TOWN OF KITTERY

ITEM 2—5 Whipple Road—Major Site Plan — Final Review

OVERALL SITE PLAN
 MAINE MEAT BUTCHER & RESTAURANT
 5 WHIPPLE ROAD, KITTEERY, MAINE

SCALE: 1" = 10'	APPROVED BY: MJS	DRAWN BY: MJS
DATE: 01/30/24	REVISION DATE: A : 03/22/24	
JOB NO: 23088	FILE: 5 WHIPPLE BASE.DWG	SHEET: 3

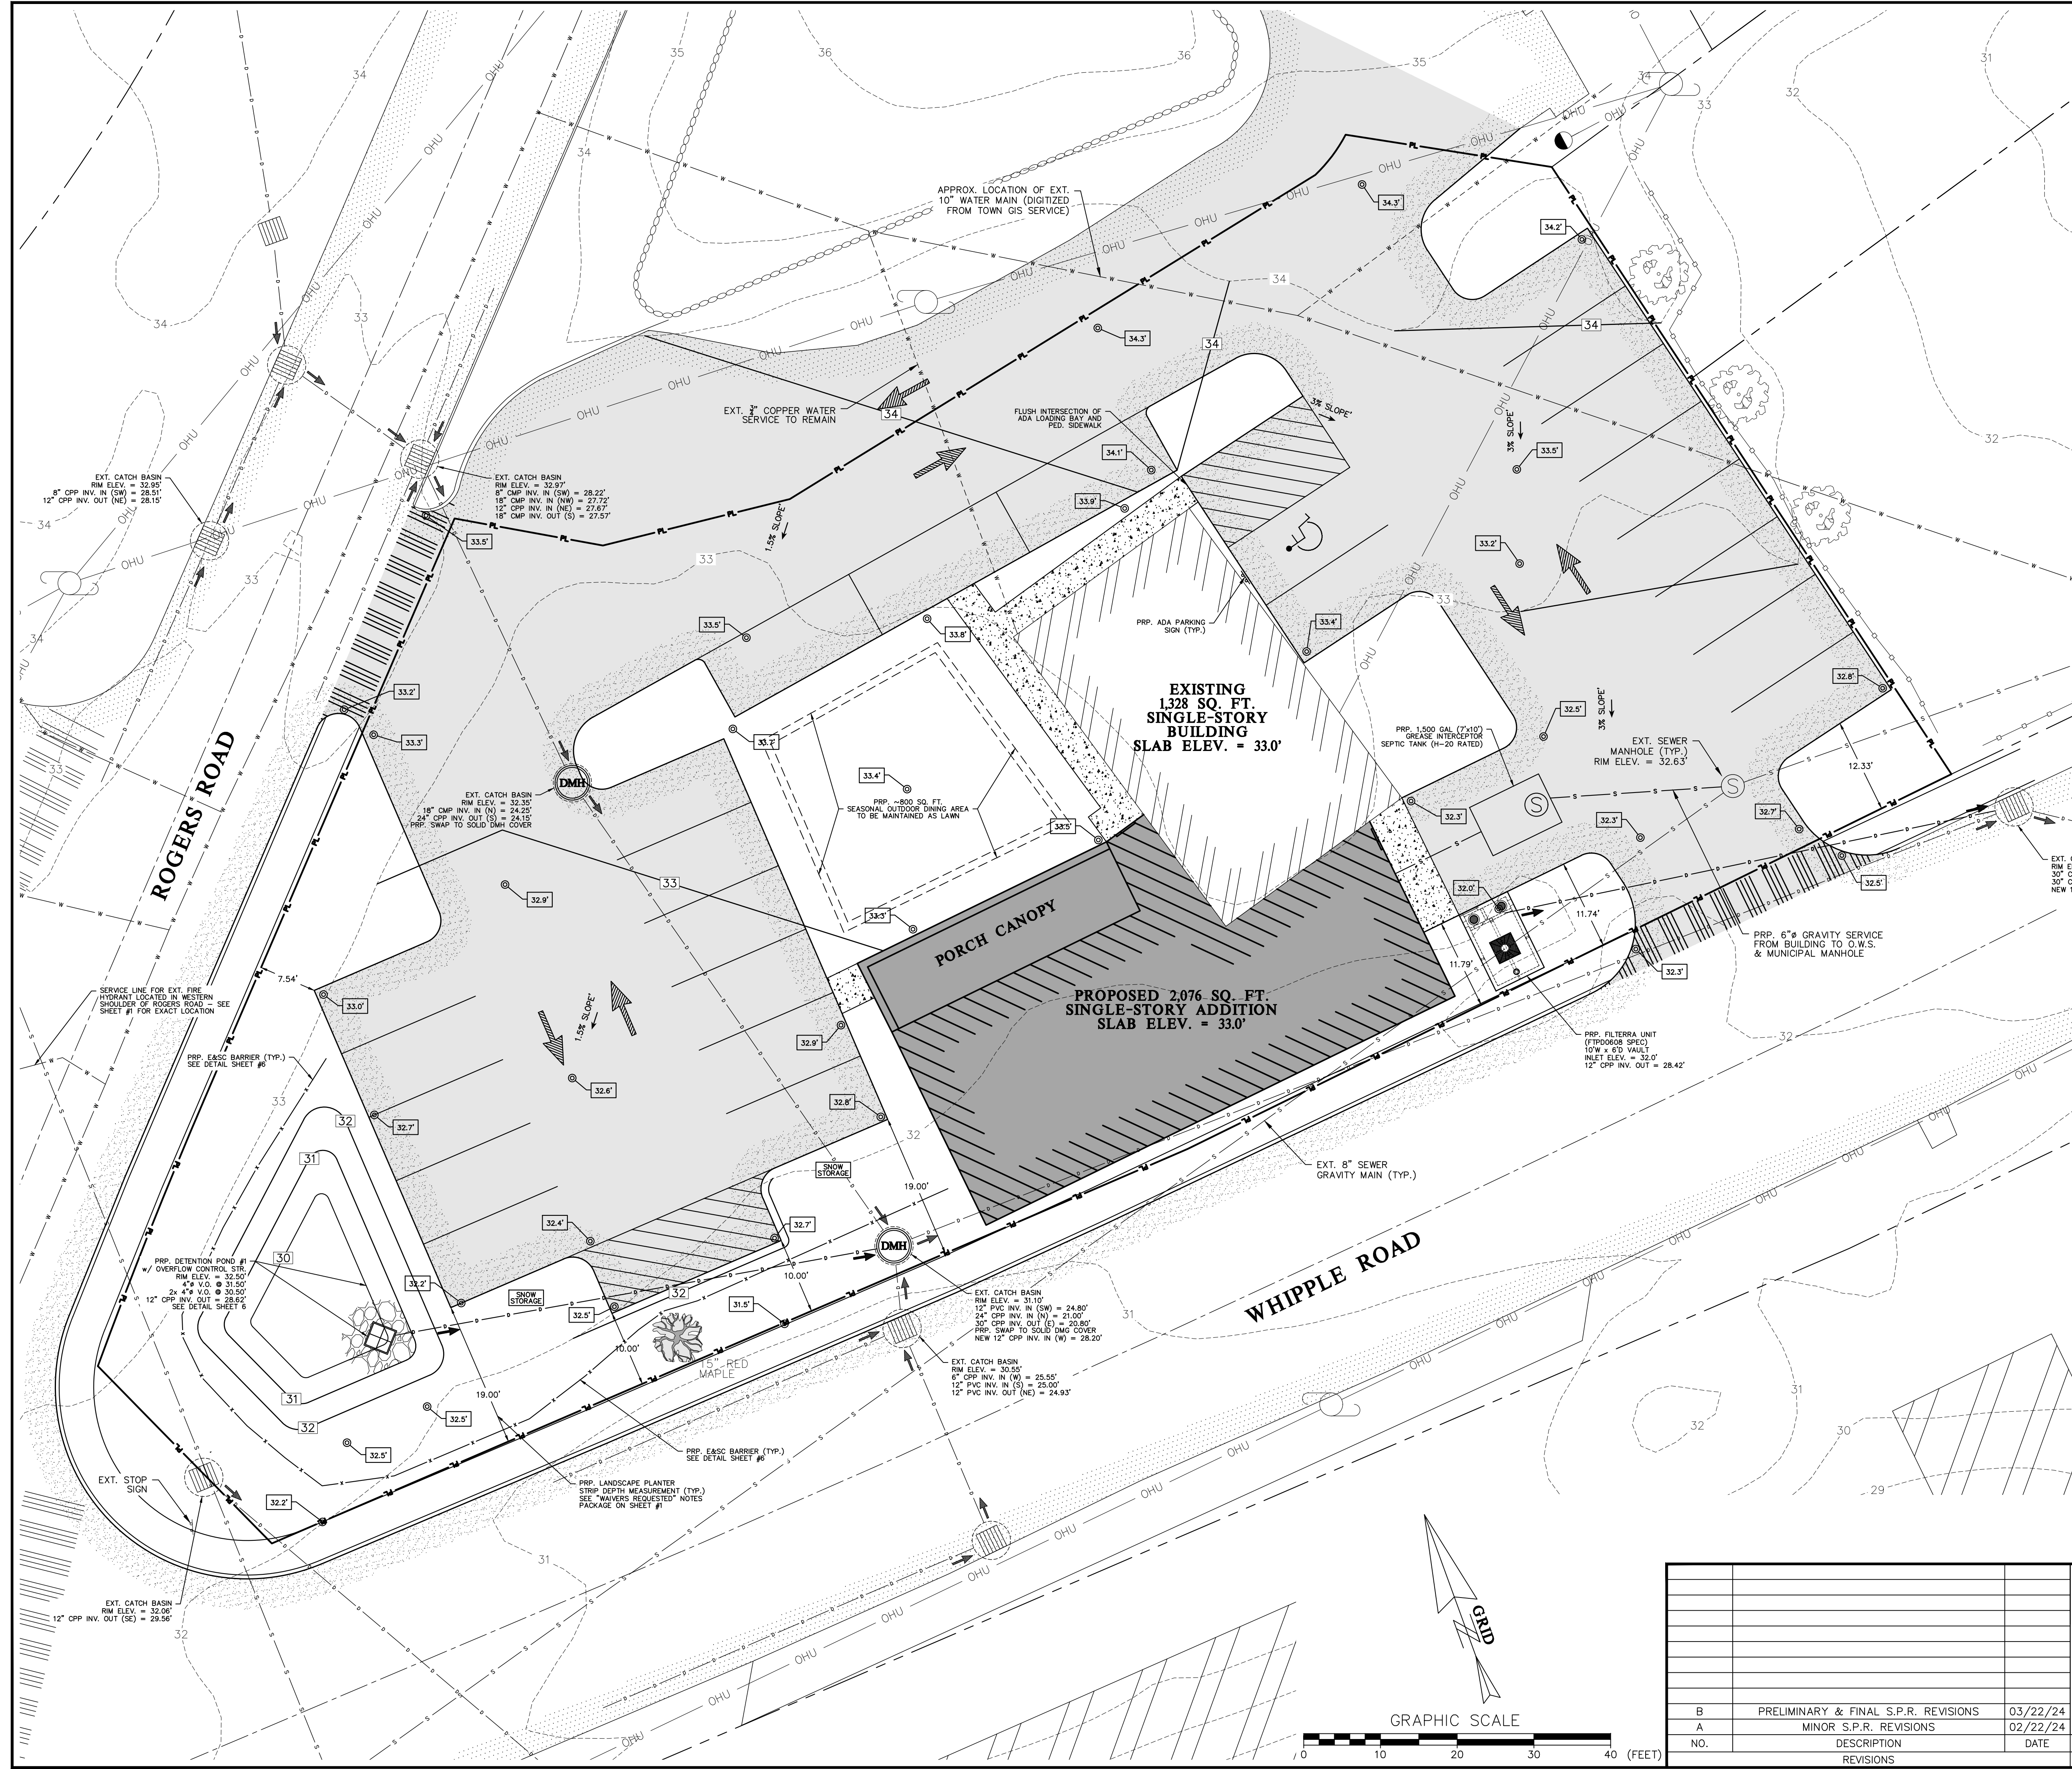
- A “Grading & Utility Notes” package has been added to Sheet #3 (Grading & Utilities Plan) which includes guidelines for stormwater infrastructure, post-construction management guidelines, snow storage language, and demonstrates the satisfaction of the proposed development with the landscaping requirements specific to the B-L zoning district per §16.4.17.D.(2).(d).

- The Applicant intends to retain the existing sewer service to the current building for the proposed butcher and specialty grocer use. Sheet #3 (Grading & Utilities Plan) has been updated to include a proposed 6"Ø gravity sewer line, which shall service the commercial kitchen associated with the proposed restaurant use. This gravity line shall be received by a 1,500 gallon grease interceptor sited beneath the proposed shipping bay before ultimately connecting to the nearby municipal sewer manhole and 8" gravity main.

- Sheet #3 has been revised to include a callout for the nearby existing fire hydrant in the western shoulder of Rogers Road. This structure is not visible from the viewport of Sheet #3, but reference is made to Sheet #1 where the scale is larger enough to provide the exact location.

- Sheet #3 has been revised to include additional spot grade elevations at the proposed travelway entrances and interfaces with the curbed concrete sidewalk. Depicted spot grades originate from survey-locating raised sidewalks in preparation of the project's Boundary Survey.

- Sheet #3 has been revised to include the location of erosion and sedimentation control measures to be installed around the site.
- Sheet #7 (Site Details) has been revised to include Filterra details previously provided in a separate cut sheet outside of the Plan Set.

OVERALL LANDSCAPE PLAN
 MAINE MEAT BUTCHER & RESTAURANT
 5 WHIPPLE ROAD, KITTERY, MAINE

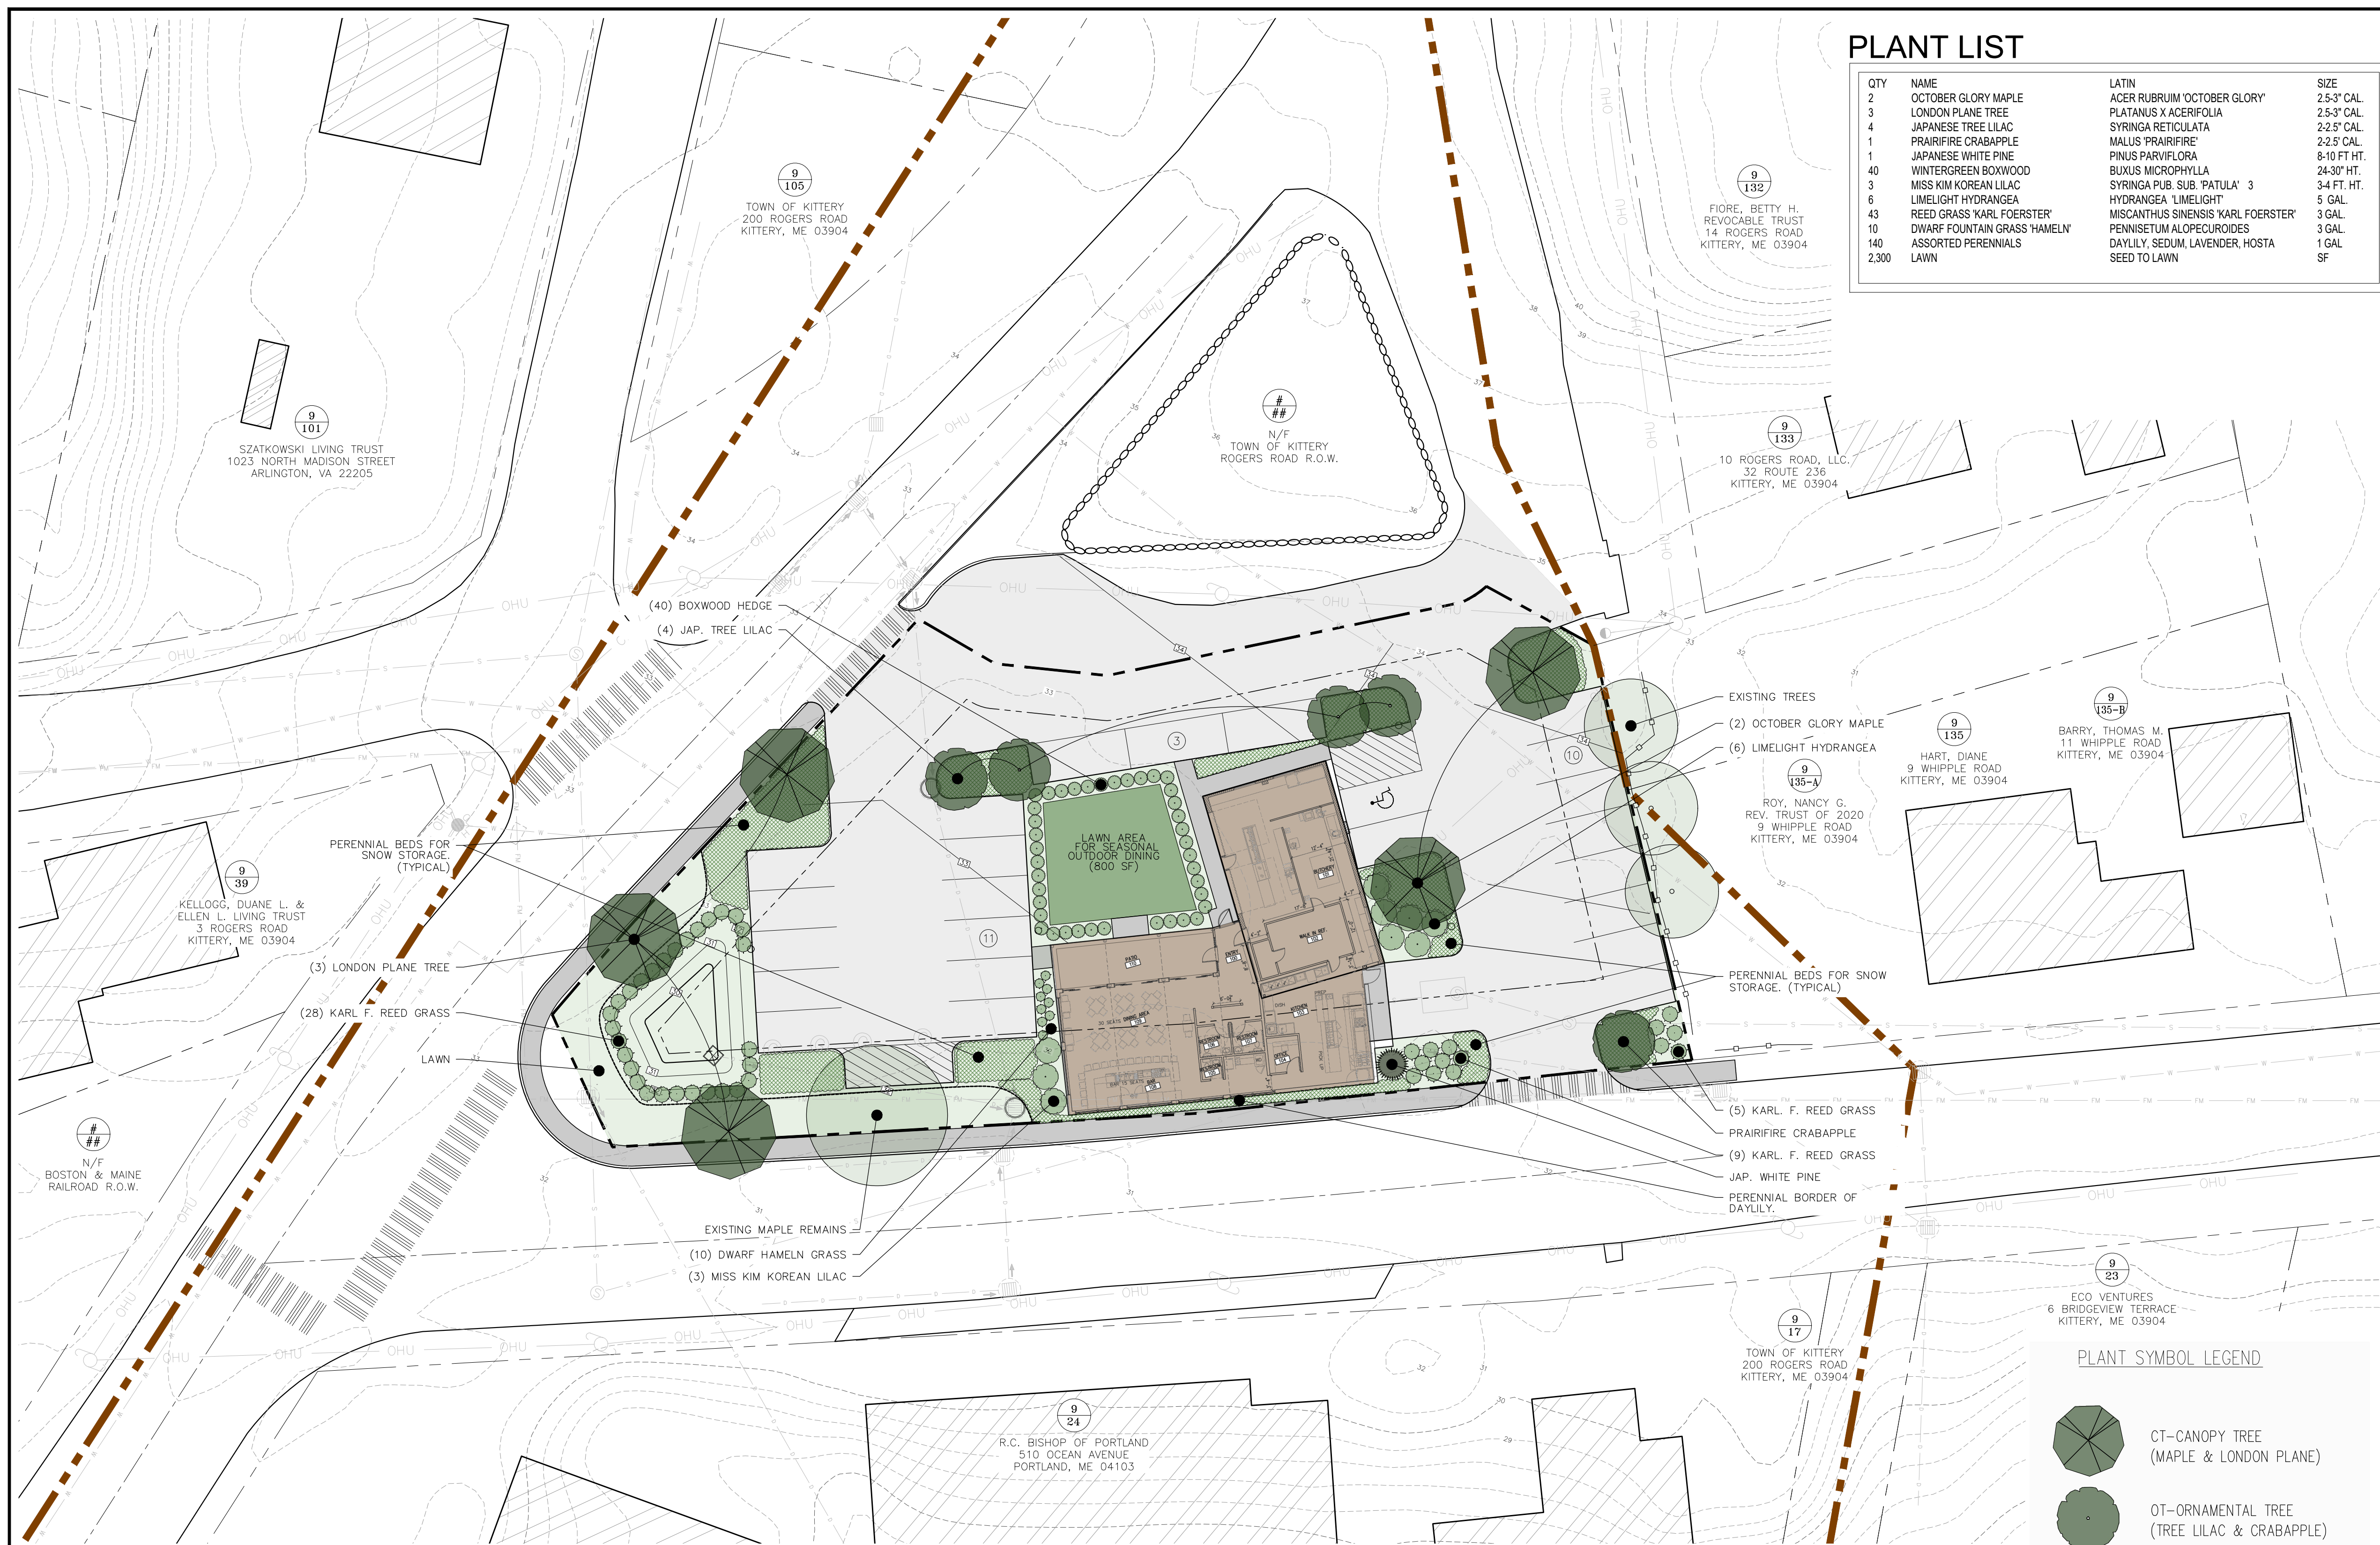
- Sheet #5 (Overall Landscape Plan) has been prepared in collaboration with licensed Landscape Architect Mr. Scott Strynar and is included in the Plan Set. Landscaped area compliance achieved from this plan is summarized on Sheet #3 as described above, and waiver requests associated with this plan are summarized on Sheet #1 as also described above.
